<u>Medway Commons – BrightPath Child</u> <u>Care Center – Minor Site Plan</u>

Re: Bright Path Child Care Center Minor Site Plan Review 67C Main Street Medway, Massachusetts

Bright Path Child Care Center Minor Site Plan Review June 9, 2022 Review Letter

C-103

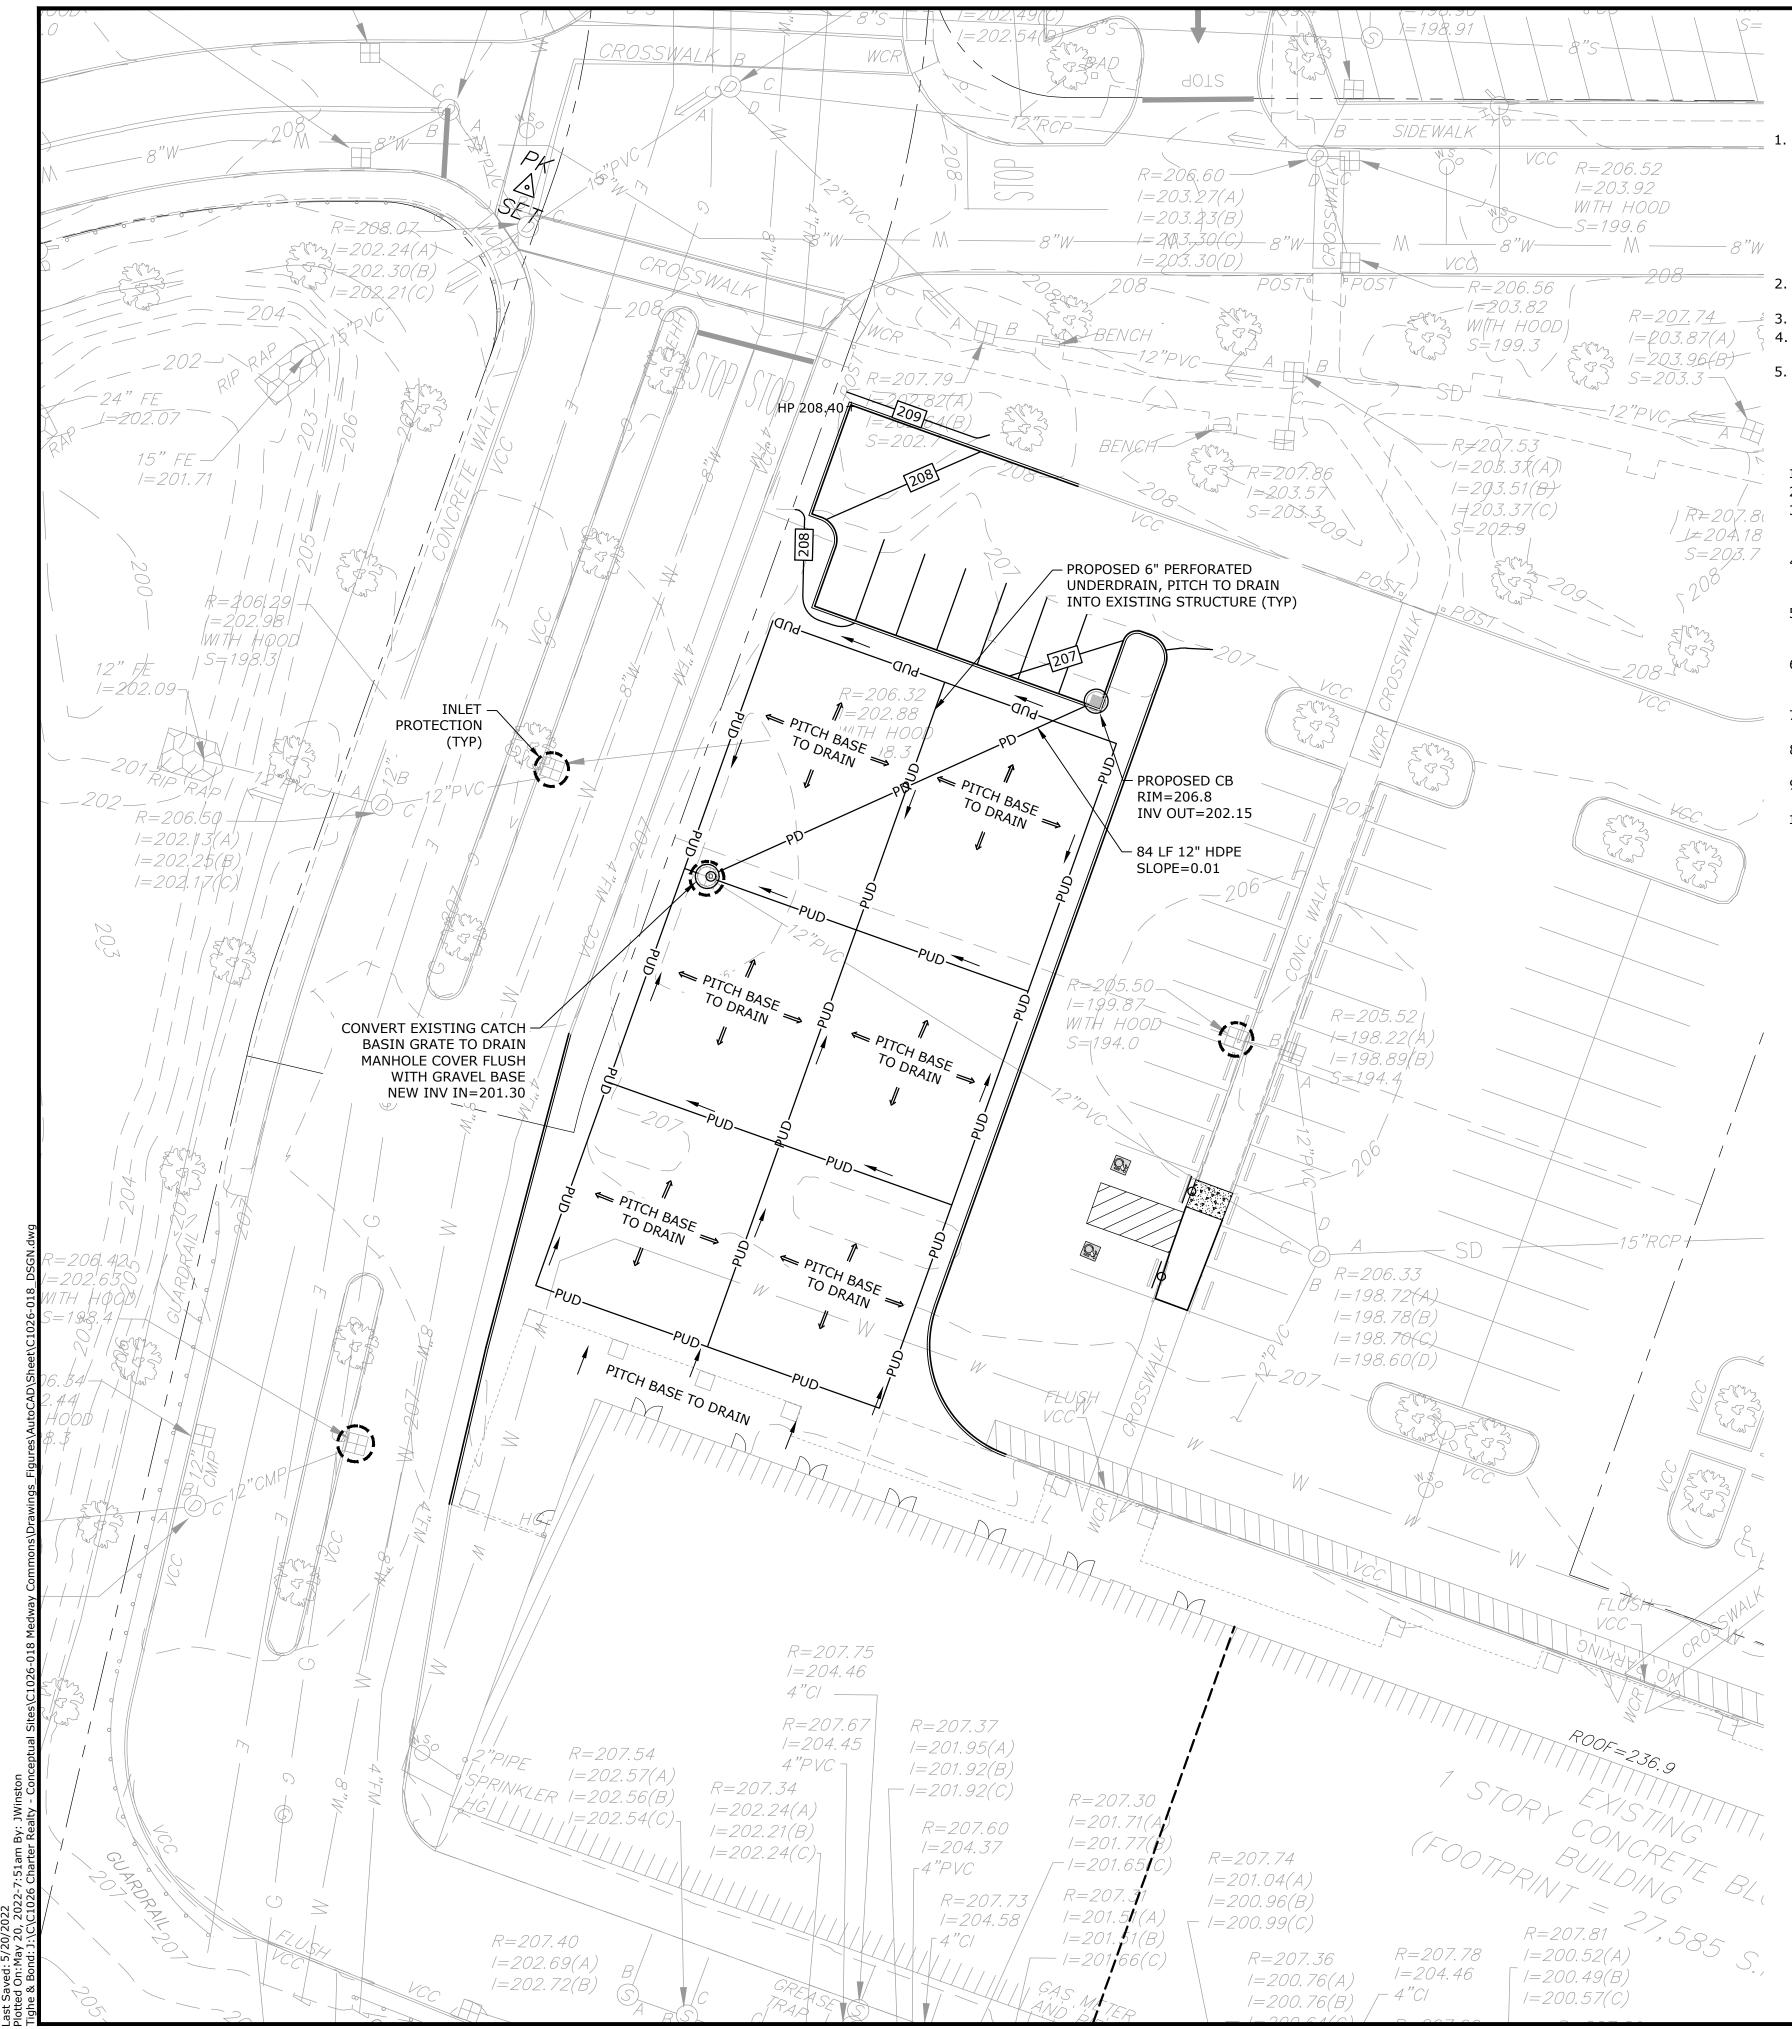
- 12. It appears proposed grading (207 contour) is outside of the limits of the proposed paving. We recommend the Applicant repave the entire area north of the proposed playgrounds (continue the sawcut on the eastern side of the playground north to the existing curb) to reduce any issues with matching existing conditions in that area while also reducing the length of joints. This will also provide a cleaner aesthetic to the Project by limiting jogs in new vs. old pavement.
